Item Name: Crosstube Turning Detail

DART AEROSPACE LTD		Work Order:	111801
Description: Crosstube Assembly (205/212/412 High Fwd)		Part Number:	D212-664-141
Inspection Dwg: D212-664-141 Rev: D		Page 1 of 2

DRAWING NO. D212-664-141	TITLE XTUBE ASSY (205/212/412 HI FWD)	REV. D	DART AEROSPACE LTD ENGINEERING ORDER		D.E.O. NO. D212-664-141-D-1	SHEET NO. SHEET 1 OF 2	SCALE NTS
DRAWN	CHECKED	MP	MFG. APPR.	APPROVED	DE APPR.		
DATE 11.04.07	DATE 11.04.11		DATE 11.04.12	DATE 11/04/12	DATE 11.04.12

ADD AN INSPECTION WINDOW TO UNDERSIDE OF CROSSTUBE.

D212-664-141/-141B
ASSEMBLY DETAIL

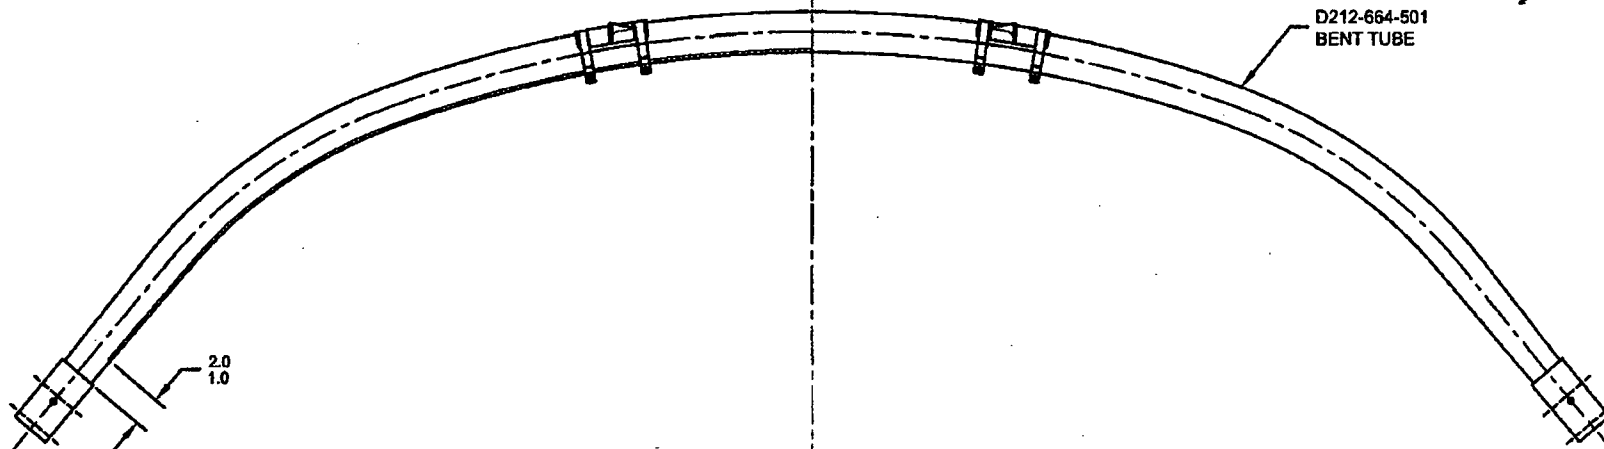
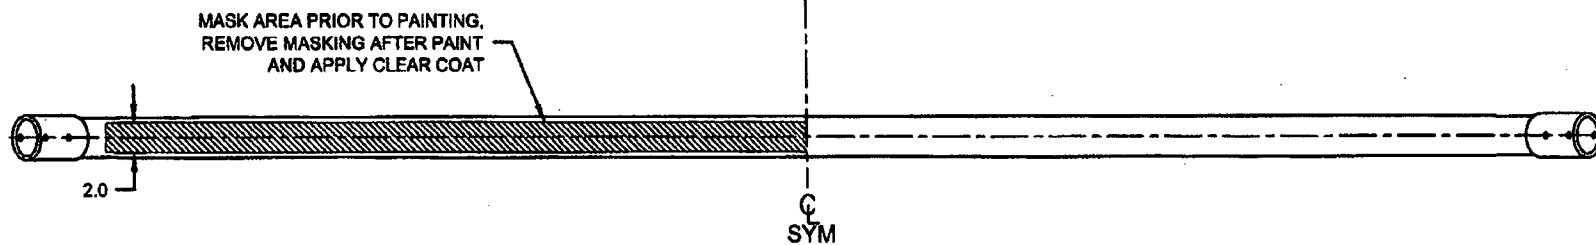
PURPOSE:

NOTES 2 OF SHEET 1 IS AMENDED AS FOLLOWS:

- 2) FINISH: CHEMICAL CONVERSION COAT PER DART QSI 005 4.1
PRIME INSIDE AND OUTSIDE PER DART QSI 005 4.2
MASK UNDERSIDE OF CROSSTUBE AS SHOWN (HATCHED AREA) AND
PAINT OUTSIDE PER DART QSI 005 4.2
REMOVE MASKING AND APPLY CLEAR COAT
